PREPARED FOR THE PLAN COMMISSION

**Project Address:** 940-1040 S High Point Road, 1051 S Pleasant View Road, and 902 Landmark Trail

**Application Type:** Zoning Map Amendment and Preliminary Plat

**Legistar File ID #** [85814](#) and [85415](#)

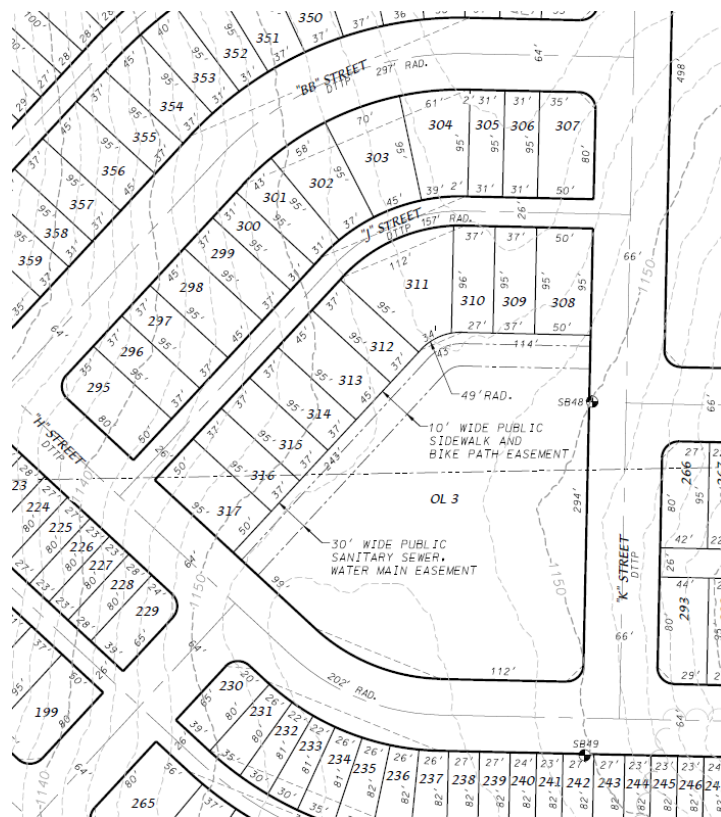
The development team has worked closely with City staff to size the streets across the plat to fit the requirements of the Complete Green Streets Guide. Conceptual cross-sections of the various street types requested and a corresponding guide to where those street types will be located throughout the 213.7-acre plat are included in the 'Hill Valley Plans' materials attached to the preliminary plat legislative file [85415](#). As shown on the conceptual plans, the applicants are anticipating that on-street parking will be provided on all local streets and along "N" Street, which will be classified as a 'Community Connector' per the Guide. The listing of which streets in the plat correspond to the various applicable street types in the Complete Green Streets Guide may be found in the comments and conditions submitted by the Traffic Engineering Division in the 'Recommendations' section of this report. Final approval of the construction plans for individual streets will be granted by the Common Council following review by the Transportation Commission and Board of Public Works and approval of the final plat(s) of the subdivision. Consistent with conditions on other recent subdivision approvals, staff is requesting that all streets in the plat be dedicated with minimum eight-foot terraces between the curb and sidewalk.

Additionally, the applicants are requesting that parking be provided along the west side of S High Point Road in front of the single-family residences planned for Lots 40-59 between "E" and "H" Streets, which will be otherwise accessed by a mid-block alley. The applicants have indicated that the High Point parking lane is necessary to support the east-fronting single-family residences and that without it, they may need to redesign the subdivision to create lots that back onto High Point like the development pattern to the east in the Valley Ridge subdivision. The cross-section of S High Point Road adjacent to the subject site was the subject of a discussion at the November 20, 2024 Transportation Commission meeting, where Traffic Engineering Division staff presented options with and without parking on the west side of High Point. On a 6-2 vote, the Transportation Commission voted to support the cross-section option **with** parking on the west side of S High Point Road adjacent to Lots 40-59. Despite concerns by some members of the Commission about high speeds along this section of High Point potentially creating an unsafe condition for vehicles using the proposed lane configuration, other members noted that the development pattern proposed by the applicants and resulting number of dwelling units was worth trying to accommodate a parking lane compared to continuing the existing development pattern located to the east. The cross-section concepts presented to the Transportation Commission are attached to ID [85415](#) for reference purposes. The 100 feet of right of way proposed along that section of High Point should be adequate to accommodate the proposed cross-section that includes an on-street parking lane.

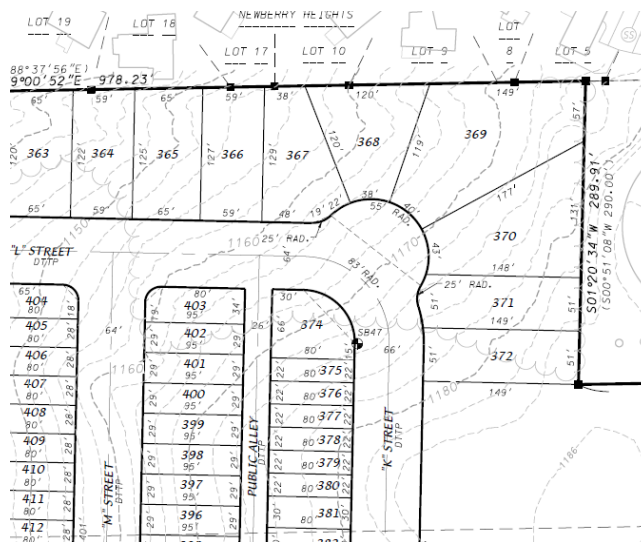
- **“J” Street and Outlot 3:** Currently, the plans for *Hill Valley* call for Lots 308-317 to front onto a private park proposed for Outlot 3 at the corner of “H” and “K” Streets on the eastern side of the development. Access to those lots, as well as Lots 295-307 fronting onto “BB” Street, will be provided by a 26-foot wide alley right of way labeled as “J” Street.

lots have typically designed to have their front doors facing the park consistent with a recommendation in Section 28.137(2)(b) of the Zoning Code (“...residences constructed on the lots abutting [a] park should have entry doors facing the park”), those doors are located on the side opposite the one that police, fire, and emergency medical services would respond to, which has created a concern about creating inefficient emergency response to these residences that the Fire Department wishes to avoid going forward.

Secondly, “J” Street does not meet the minimum requirements for an alley providing the sole means of access to the abutting lots in the Subdivision Regulations, which would be required to provide a minimum 20-foot wide driving surface. The 20-foot alley width corresponds with the minimum fire lane width required by the Fire Prevention Code (MGO Chapter 34). However, as a named street as compared to an alley, “J” Street would need to be designed as a Complete Green Streets Guide-compliant street type, which would likely result in a wider right of way and paved area than an unnamed alley, and may also require sidewalks and terraces consistent with a conventional street design. As an example, “J” Street may have to be designed to meet the minimum requirements of a Neighborhood Yield Street (46-foot minimum right of way), or as a Neighborhood Shared Street, which the Guide does not contain minimum parameters for due to the flexibility for such streets.

Instead of the proposed configuration shown on the preliminary plat for the block bounded by Streets “H,” “K” and “BB,” staff recommends that a different layout be pursued that would alleviate the public safety access and design concerns above. One potential solution discussed calls for “I” Street to be extended westerly across the block to “BB” Street with alley-loaded lots to front “H” and “I” Streets and the park outlot relocated to the northern portion of the block.

2. The applicant shall revise the plat to redesign the block bounded by “H” Street, “K” Street, and “BB” Street to provide adequate fire access for all of the lots on that block and a Complete Green Streets Guide- and Subdivision Regulations-compliant street or alley to provide access for this block.
